Reference: C.N.806.2001.TREATIES-1 (Depositary Notification)

REGULATION NO. 100. UNIFORM PROVISIONS CONCERNING THE
APPROVAL OF BATTERY ELECTRIC VEHICLES WITH REGARD TO
SPECIFIC REQUIREMENTS FOR THE CONSTRUCTION AND
FUNCTIONAL SAFETY

PROPOSAL OF AMENDMENTS TO REGULATION NO. 100

DRAFT SUPPLEMENT 1 TO REGULATION No. 100

Figure 7.1
Determination of hydrogen emissions
during the charge procedures of the traction battery

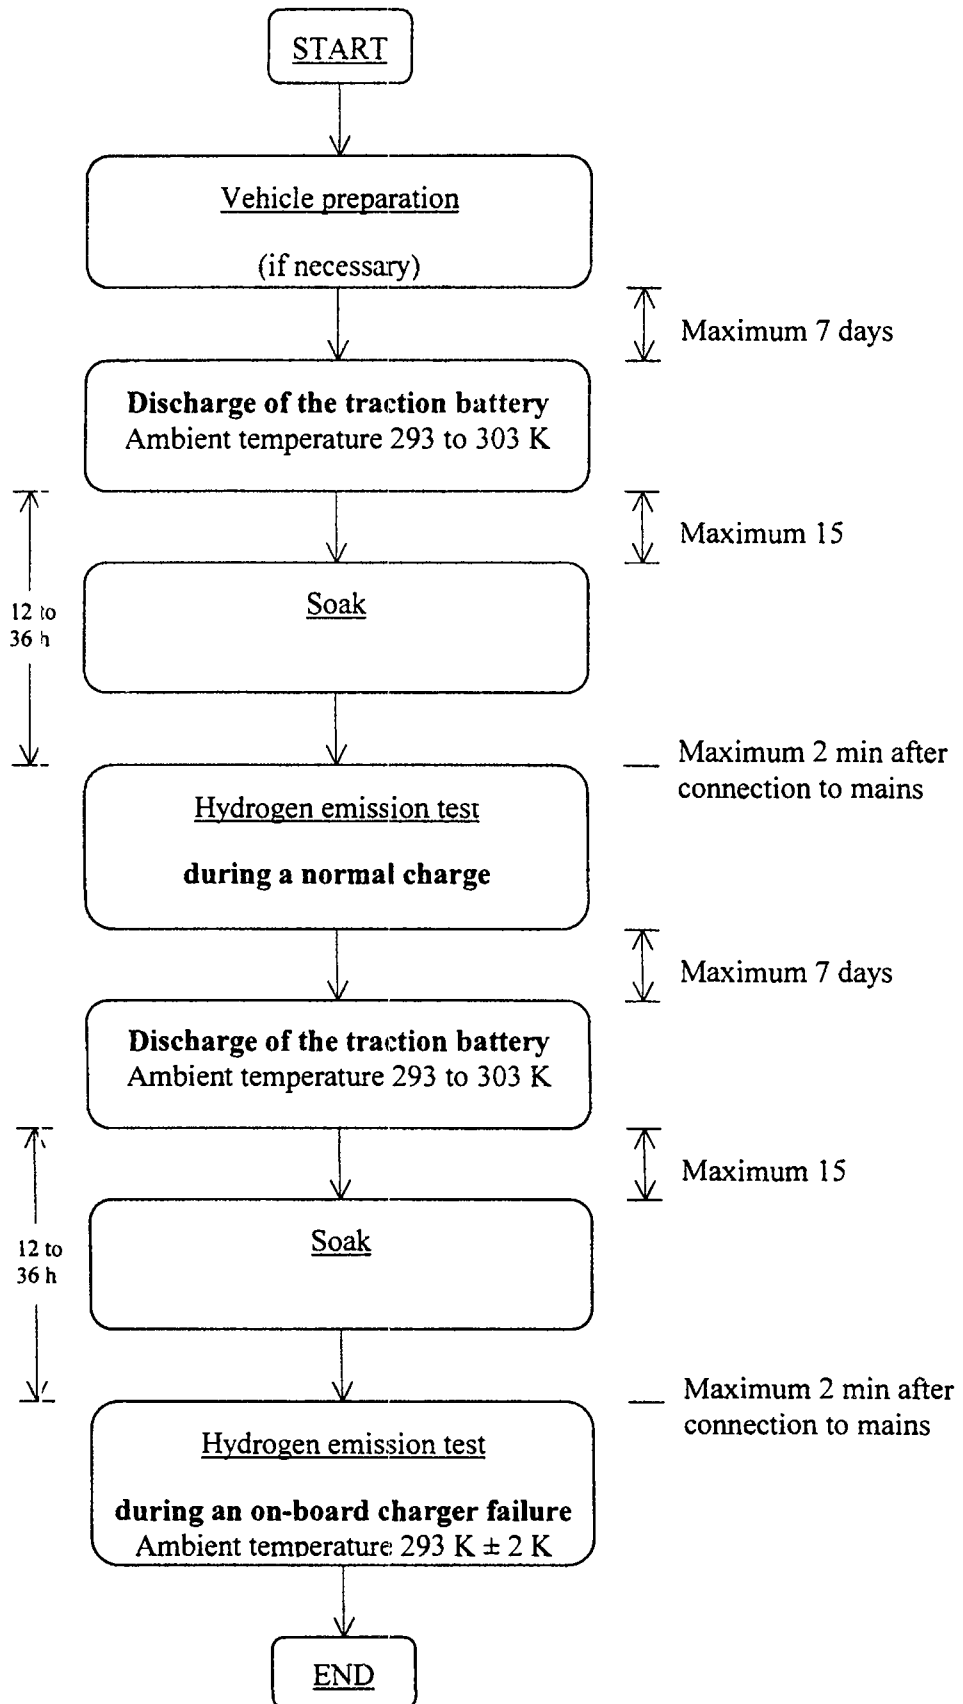
Insert a new Annex 7, with Appendices 1 and 2, to read:

The hydrogen emission test (Figure 7.1) is conducted in order to determine hydrogen emissions during the charge procedures of the traction battery with the on-board charger. The test consists in the following steps:

- (a) vehicle preparation,
- (b) discharge of the traction battery,
- (c) determination of hydrogen emissions during a normal charge,
- (d) determination of hydrogen emissions during a charge carried out with the on-board charger failure.
